UNITED STATES PATENT AND TRADEMARK OFFICE

Office Action Summary

10/830,207

TJAKRA, HORACE

Figure 8: Wirkus et al. (US 5,845,443)

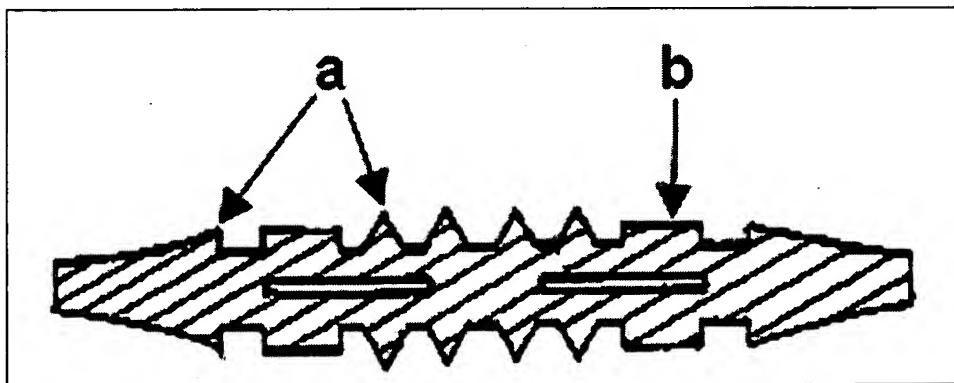
- An elongated spacer having a profile that can possibly correspond to the channels of the glass block (figures 8-9 and column 3, lines 27-30);
- A plurality of projections (items a and b) that extend outward from the profile of the spacer (annotated figure 8 and column 3, lines 31-34);

Regarding claims 5 and 6: Wirkus further discloses a plurality of projections that are ridges (item b) or steps (annotated figure 8). Since it's unclear what the difference between a step and ridge is, it's the examiner's stance that the ridge and step are one in the same.

Regarding claim 7: Wirkus further discloses a plurality of projections that are ridges (item b) and pointed projections (item a, annotated figure 8).

Regarding claim 9: Wirkus discloses an elongated spacer comprising a plurality of projections (items a and b) shaped as steps, ridges (items b) or pointed (item a) projections that extend outward from the profile of the spacer (annotated figure 8 and column 3, lines 31-34).
